Common Structural Rules for Bulk Carriers

Proposals for the calculation of the dry bulk cargo's upper surface height

20 May 2009

Figure 1: DNV proposal.

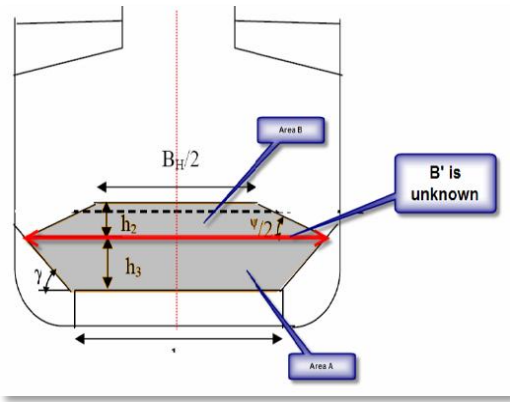
with the following assumptions:

- h_3 only to be calculated when h_1 is less than 0
- Volume of transverse stools is assumed to be fully considered regardless of shape and height of cargo (Conservative)

Figure 2: BV first approach.

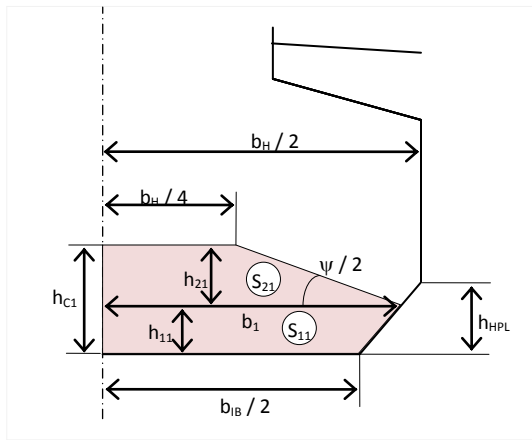
As DNV, it is considered that the breadth of the horizontal part of the cargo's upper surface is $b_H / 2$ and that the volume of the lower transverse stool is fully considered in the calculations.

Figure 3: BV second approach.

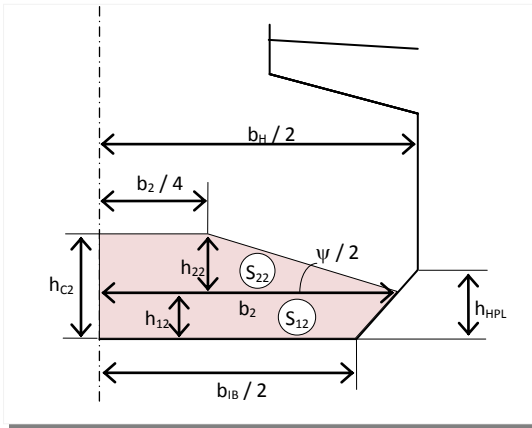
Here the assumption is made that the breadth of the horizontal part of the cargo's upper surface is half of the breadth of the cargo's upper surface at its lower corner, i.e. $b_2 / 2$.

Similarly to DNV, the volume of the lower transverse stool is fully considered in the calculations.

Figure 4: shapes of the cargo's upper surface.

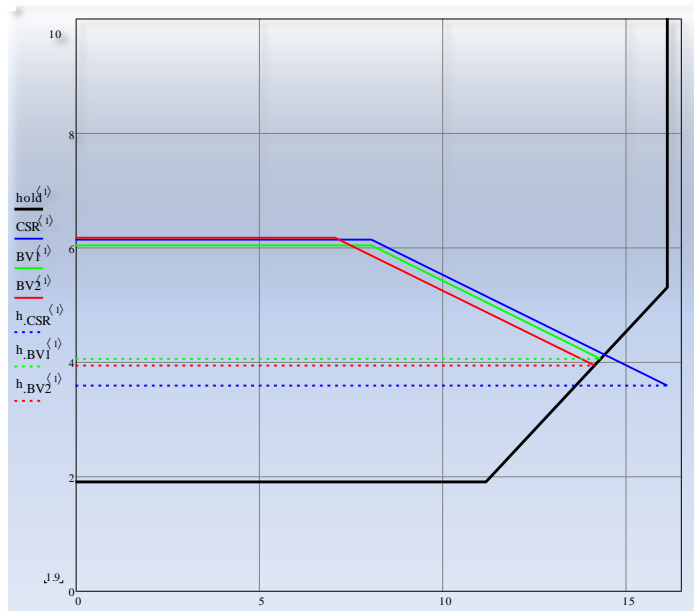
- DNV approach and BV first approach give the same results; the difference is only on the variables used in the formulas.
- The volume of the cargo is correctly given by the CSR formulation even for this kind of configuration.

- Regarding the differences between these 4 approaches:
 - All the horizontal parts of the cargo's upper surfaces are close from each others. Considering all the approximations already made for modelling the shape of the cargo, these differences are not significant;

- The sloped parts of the cargo's upper surfaces have the same inclination. Hence, the only largest difference is between the current CSR approach and the second proposal made by BV, due to the difference in breadth of the horizontal part of the cargo's upper surface. However, these differences remain small and can be neglected;

- The breadth of the hold submitted to the cargo load is significantly reduced in each of the 3 new propositions.

As the difference in the cargo height are not significant but as the impacted breadth of the hold is lesser with the new approach, it is more conservative and simpler to keep the CSR BC as they are.
